Our ref: 19D28-L3/af

**RE: MARSDEN PARK PUBLIC SCHOOL
 MARSDEN PARK, NSW
 STATE SIGNIFICANT DEVELOPMENT (SSD9809)**

The following letter is written in response to Requests for Information (RFIs) raised by Blacktown City Council dated 28/04/20 regarding the State Significant Development Application for the New Marsden Public School, Marsden Park. The letter aims to satisfy concerns relating to the civil engineering matters raised by Council's Drainage Engineers.

Revised post-development treatment train configuration.

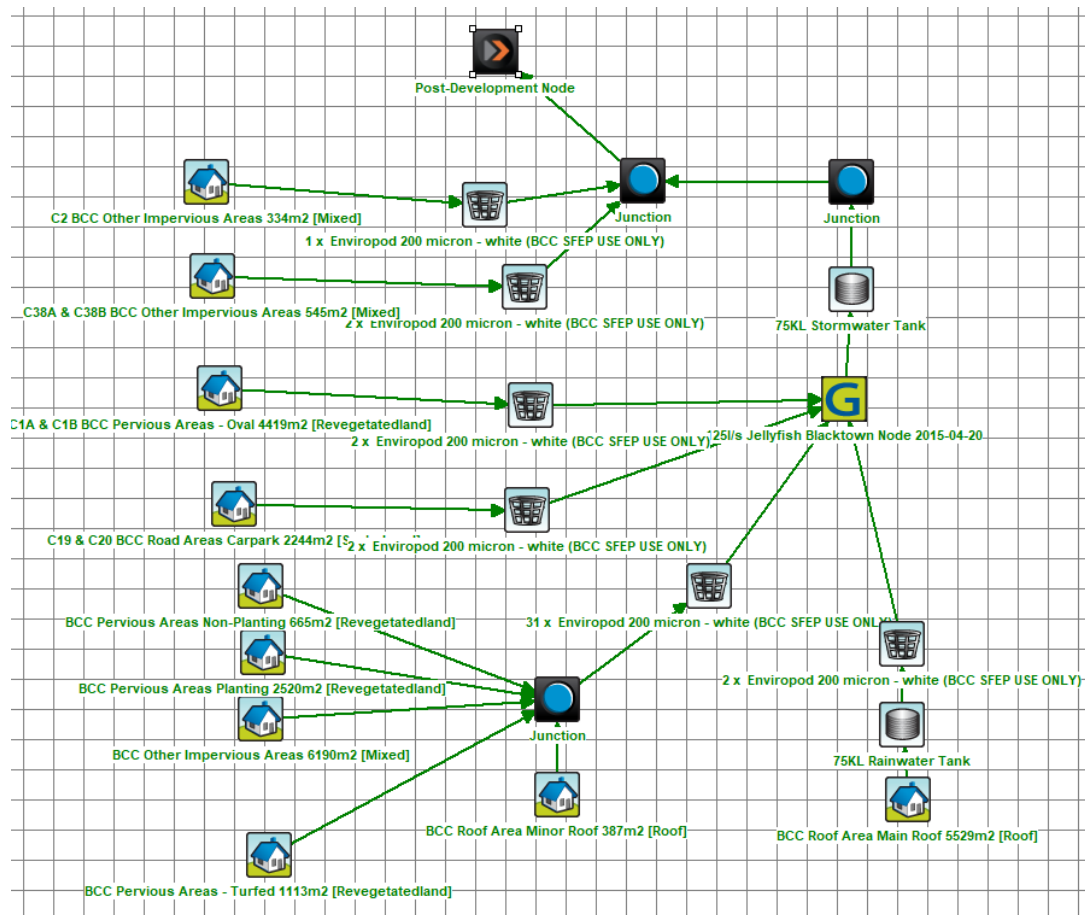
- i. The total site area (23947m²) does not match the provided MUSIC model (31100m²). Catchments C38A, C38B, C1A, C1B, C19 and C20 seem to be duplicated in the MUSIC model as part of other catchments. Amend this issue to result in reduced water quality resources than currently proposed.
- ii. 40xOceanGuards are present on the plans yet only 38 are shown in the MUSIC model. Ensure a correlation between the MUSIC model and the plans.

6.i. The submitted MUSIC model has been amended to match the correct catchments shown on revised engineering drawings 19D28_SSDA_C250 and C251. Unfortunately, water quality resources could not be reduced as Catchment Area 2 (for Pit G-2) has been included as bypass in the revised MUSIC model. Treatment reduction rates from the revised MUSIC model remain in accordance with Blacktown City Council's target rates as stated in BCC DCP Part J. See below and attached revised MUSIC model for review.

6.ii The MUSIC model has been amended to correlate with the correct number of Ocean Guards shown on revised engineering drawings 19D28_SSDA_C250 and C251. Refer above and attached revised MUSIC model for review.

Drawn I.Khachab	Designed N.Wetzlar	Date JAN 2020
Checked N.Wetzlar	Approved A.Francis	Scale @A1 1:200
Drawing number 19D28_SSDA_C102		Revision 07

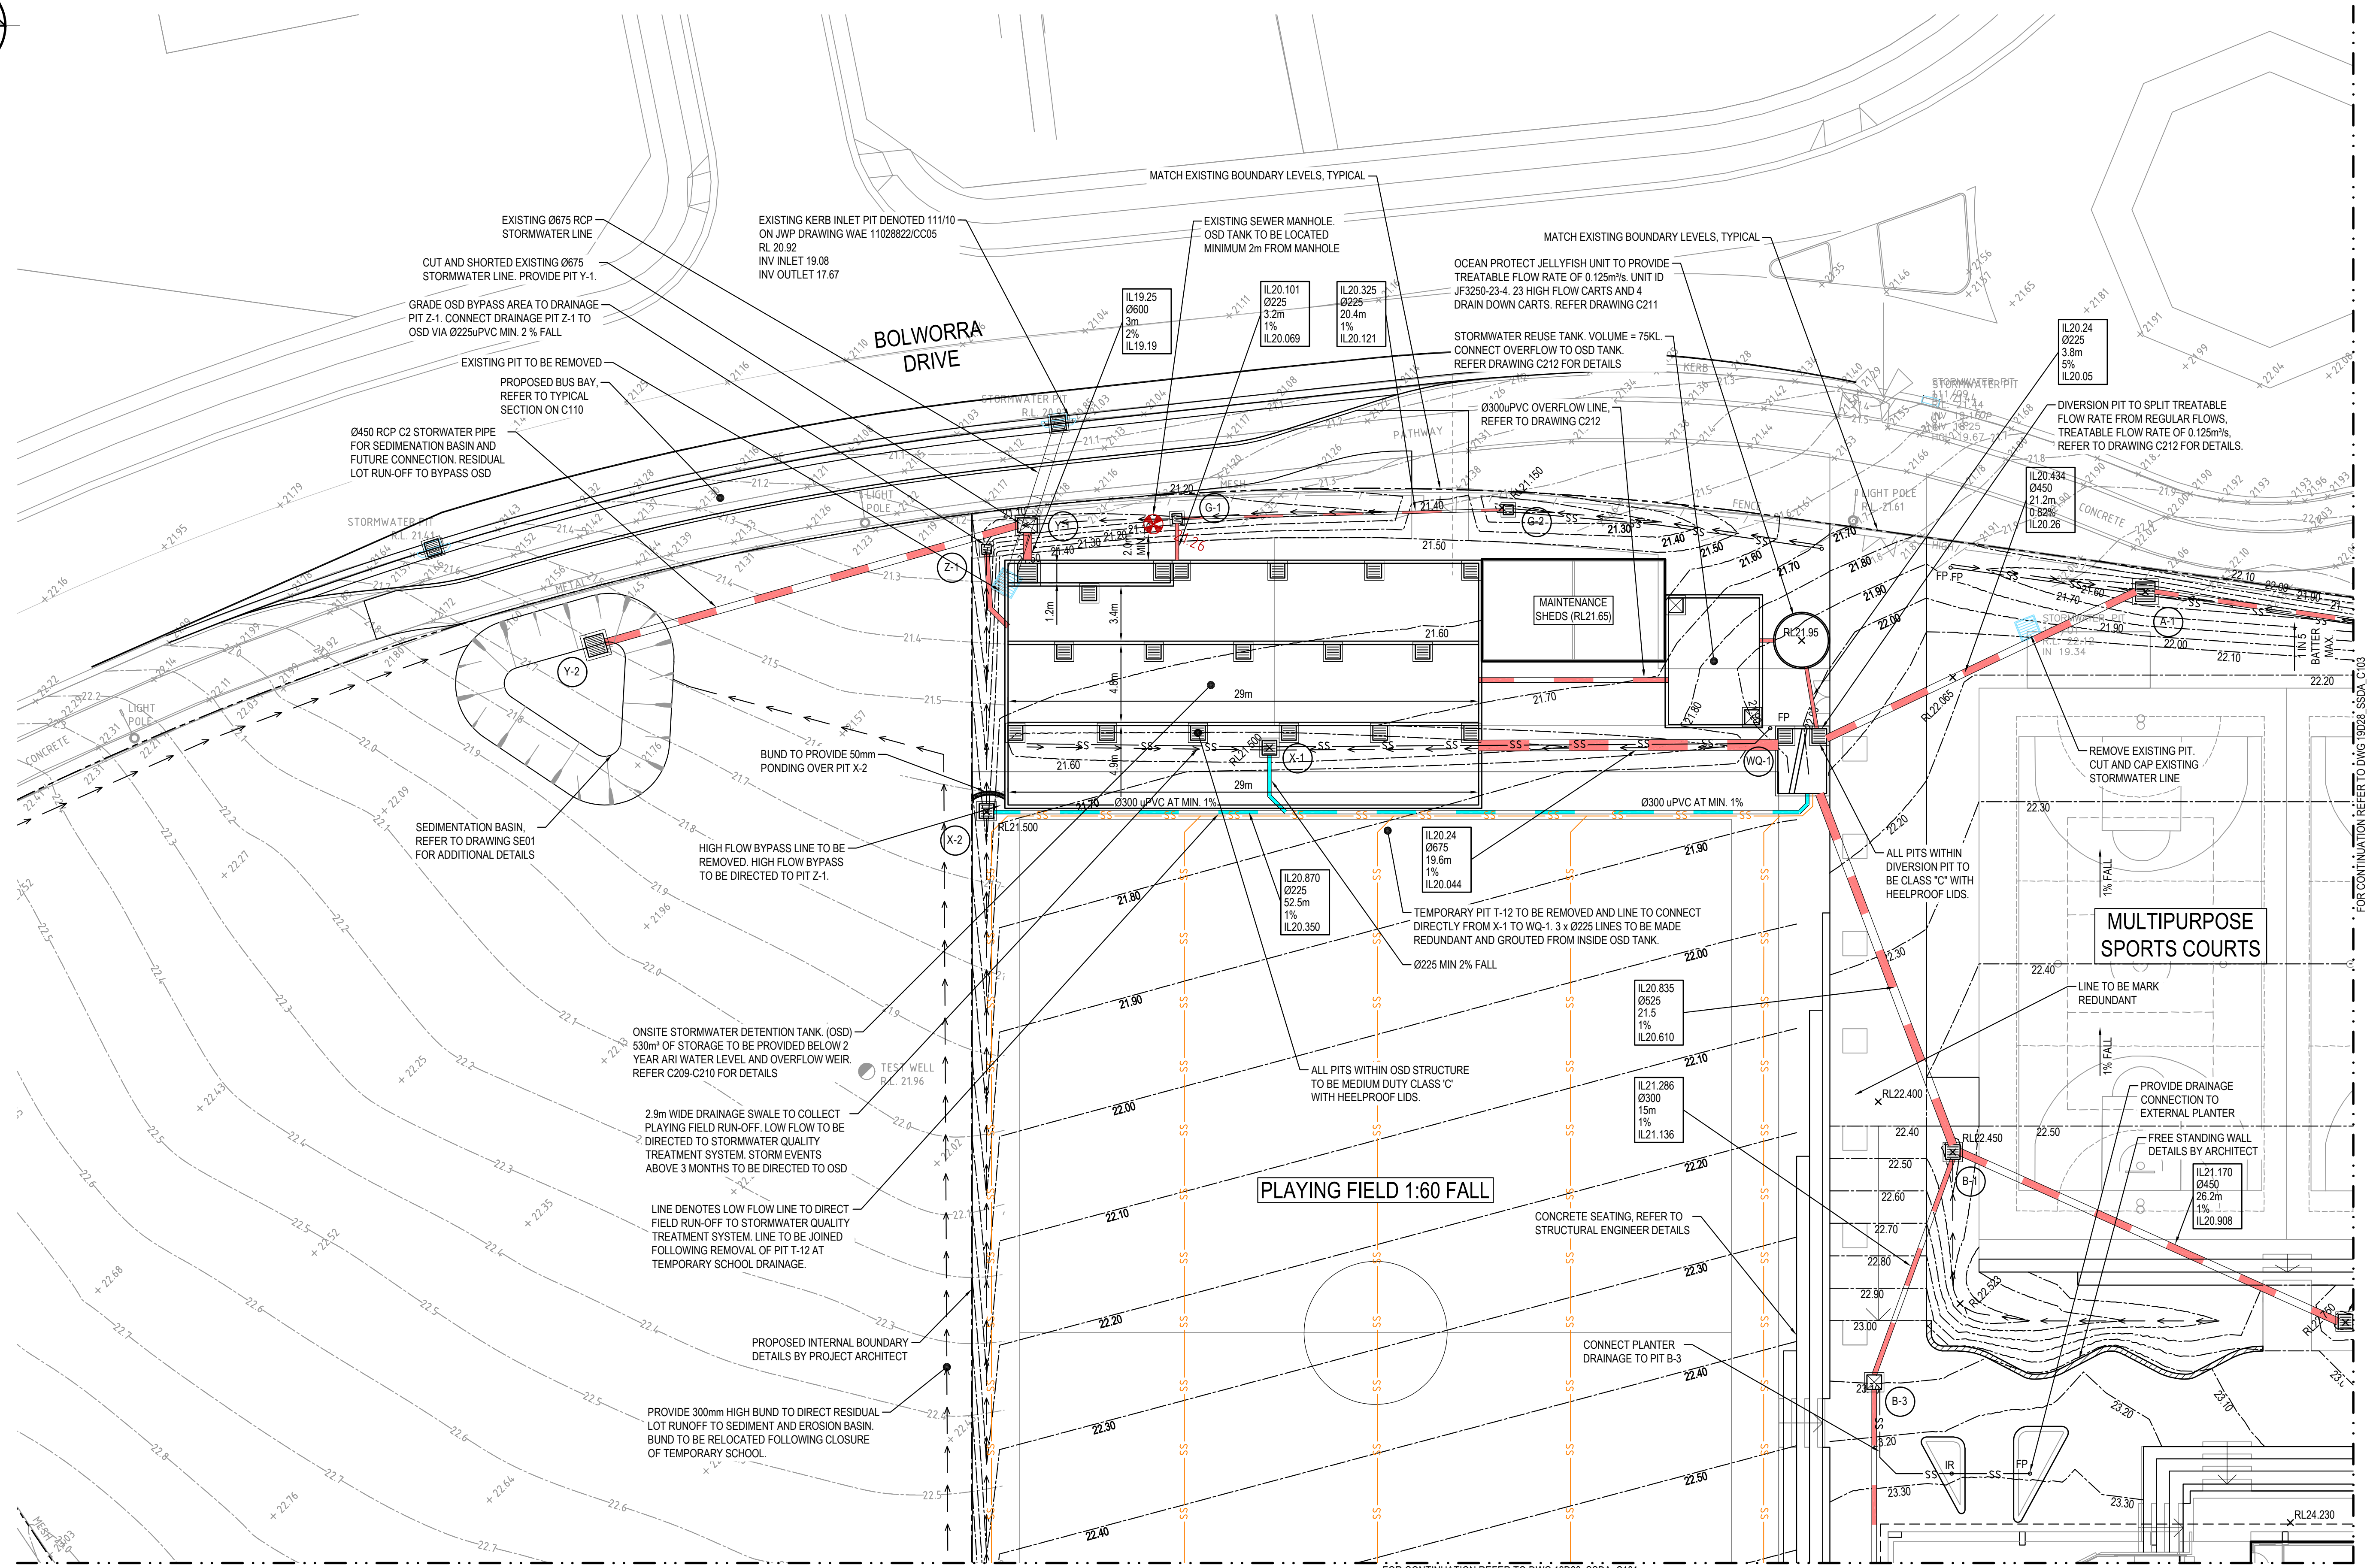
2. Amend Dwg. No. C102 (05):
- i. Council does not permit sealed pits over an OSD.
 - ii. Regrade and redirect surface flows from the playing field to flow into the diversion pit via an OceanGuard. A small portion of the playing field can bypass directly into the OSD. This will allow all OSD grates to be grated and results in a simplified design. Delete pit X-1 as a result.
 - iii. All OSD and diversion pit grates are to be heel proof due to being in vicinity of the Playing field.

2.i. Sealed pits have been removed from drawings and heelproof grated surface pits have been specified. Refer to revised engineering drawing 19D28_SSDA_C102, C209. C210 & C212.

2. ii. Current field grading has been designed to mimic the existing topography of the site, eliminating the need for retaining elements along the western boundary and to coordinate with access from Bolwarra Drive.

Further information has been provided for the low flow diversion system which diverts treatable flows collected from stormwater pits X-1 and X-2. The low flow diversion system has been designed to accommodate stormwater flow rate induced by the 6-month storm even. 6-month flow rates are as follows 25.5l/s for the catchment draining to Pit X-1 and 6l/s for catchment draining to Pit X-2. Pit X-1 requires a ponding depth of 0.05m to manage 25.5l/s and Pit X-2 a depth of 0.03m to manage 6l/s. Adjacent heelproof access pits for the OSD have been set a minimum 0.05m above Pit X-1 to allow adequate ponding to drain 6-month flows to diversion pits WQ-1. Run-off induced by storm event in excess of the 6-month storm event simply pond in the swale and drain into the adjacent pits at RL 25.55. Similarly, pit X-2 features minor bunding to allow for a minimum of 0.03m ponding to drain

treatable flows to pit WQ-1. Run-off induced by storm events in excess of the 6-month event overtop the bunding and are collected via sag pits Z-1 and G-1 and is directed to the OSD.

Although regrading the football field could simplify the stormwater design, regrading against the existing topography will result in further retaining structures, complicate access from Bolwarra Drive and intensify earthworks. It is the opinion of the applicant that a low flow diversion system allows for an optimal balance between all aspects of the civil design including stormwater.

2.iii. All OSD and diversion grates have been updated to be Heelproof grated surface pits. Refer to revised engineering drawings 19D28_SSDA_C102 and C209.

Drawn I.Khachab	Designed N.Wetzlar	Date JAN 2020
Checked N.Wetzlar	Approved A.Francis	Scale @A1 1:200
Drawing number 19D28_SSDA_C104		Revision 06

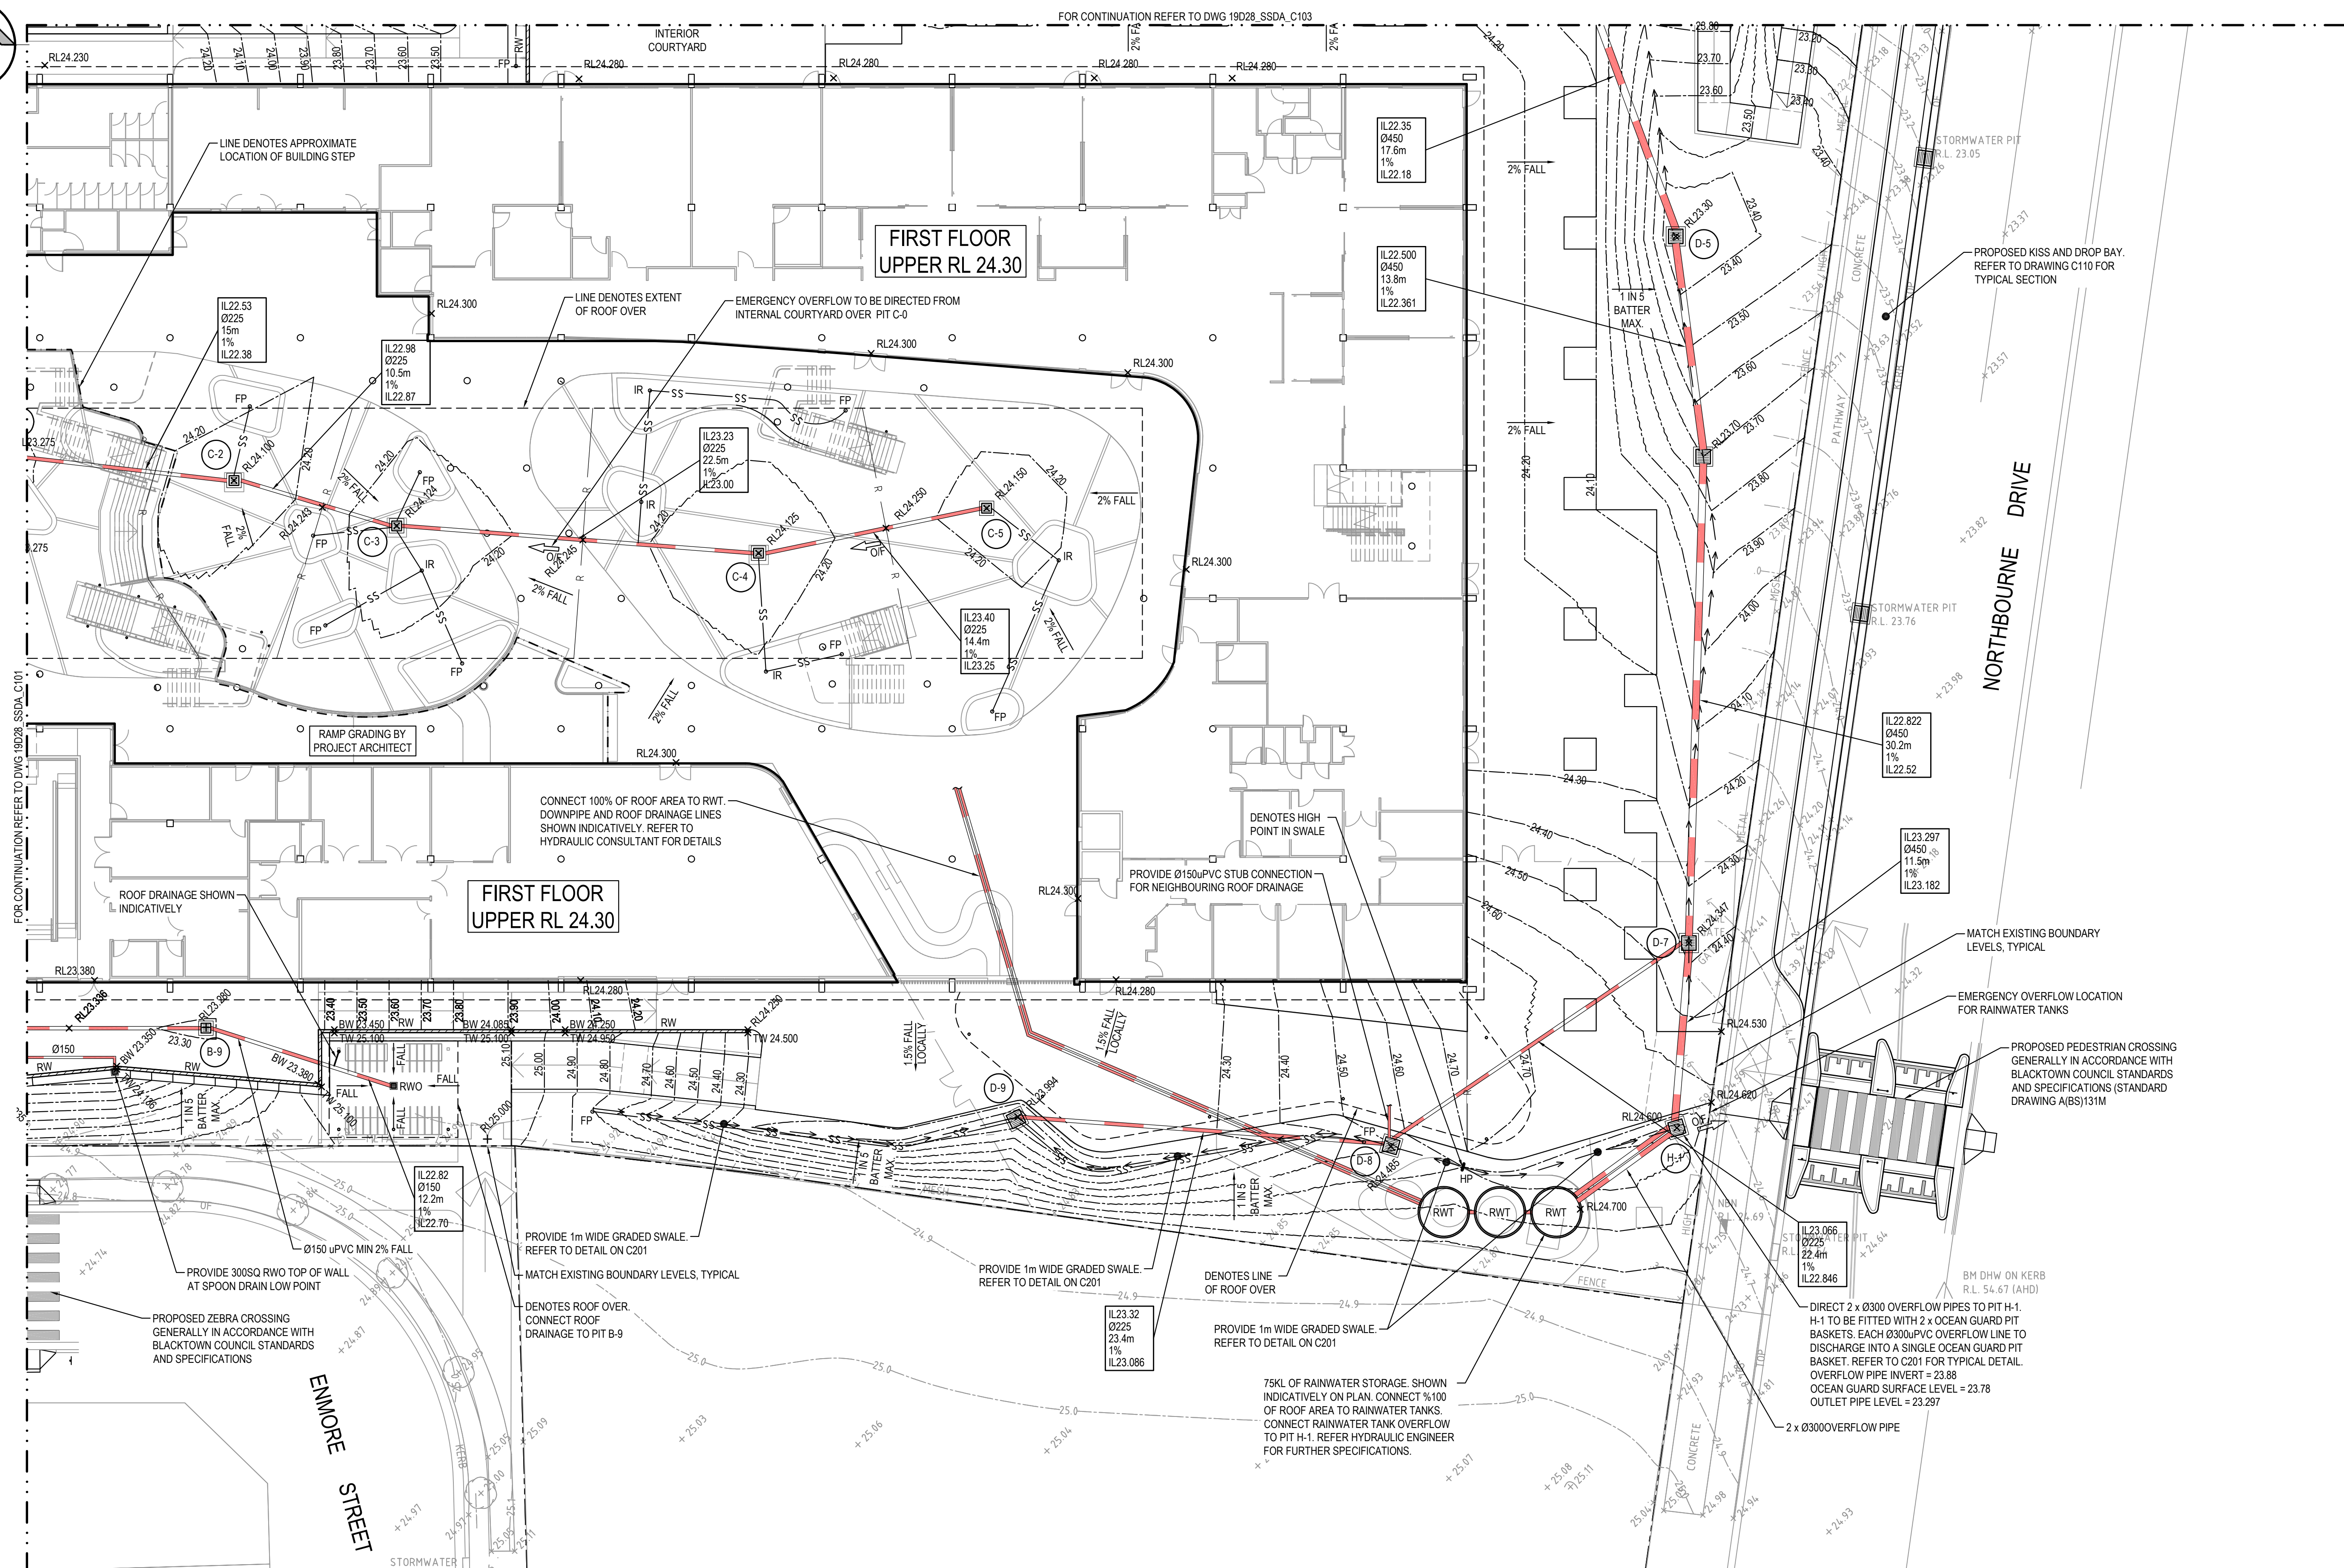
3. Amend Dwg. No. C104 (04):
 - i. Provide an emergency overflow route for major storms for the internal courtyard.

3.i. Overland flow route markers have been provided showing the location of the proposed emergency overland flow path from the internal courtyard. Additional pit C-0 has been added to improve the emergency overland flow route from the internal courtyard. Refer revised engineering drawings 19D28_SSDA_C101 and C104.
